Årsmøte NKK – 22.03.2022

REGELENDRINGER

Proposed changes to the Knarr International Class Rules by Norway and Denmark
with comments by IKA Technical Committee in blue 05 MAR 2022
NKK-TC comments in red 07-MAR-2022

C.8.6 Cockpit sole

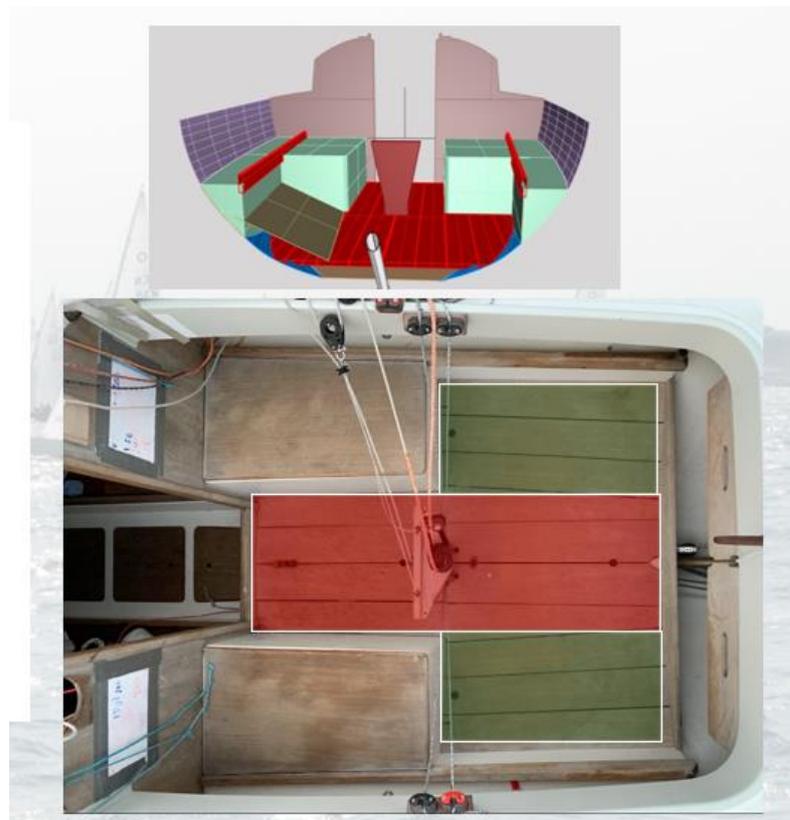
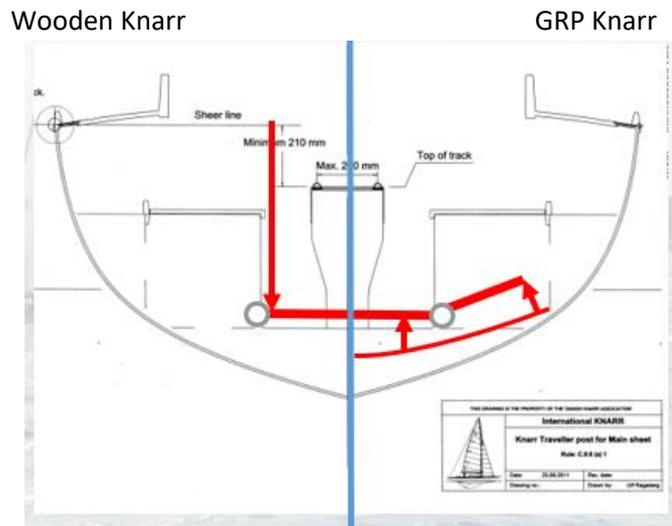
Raised cockpit sole is permitted.

1) For the wooden-Knarr the top of the cockpit sole must be minimum 610 mm below the sheerline measured at the position of the barney post. The cockpit sole must be parallel with the waterline.

2) For the GRP-Knarr the top of the raised cockpit sole must be maximum 80 mm above the GRP-cockpit sole.

In the current class rules, there is no definition of the cockpit sole or floorboards. For the GRP-Knarr the cockpit sole is defined by the moulded inner section, but there is no mention of floorboards. In several GRP-Knarrs an extra teak sole of different heights has been fitted on top of the GRP-sole. The purpose of this proposal is to set a limit on the height of the floor in the cockpit. This prevents "high-floor" solutions as in Soling, Yngling & Starboats.

D.8 THWARTS AND BENCH

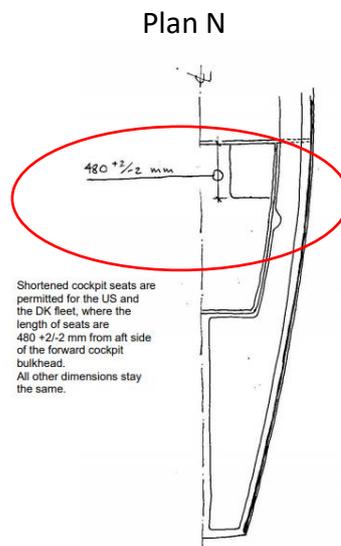
US and Danish National prescription:

Cockpit seats may be as shown on Plan N.

Following measurements performed by the Danish Technical Committee it has transpired, that shortened benches in some Knarrs do not correspond to the measurements on Plan N. To avoid costly rebuilding, the Danish fleet has therefore approved the following measurements as a new Danish national prescription to be written on to Plan N:

515 mm + 35 mm and -4 mm
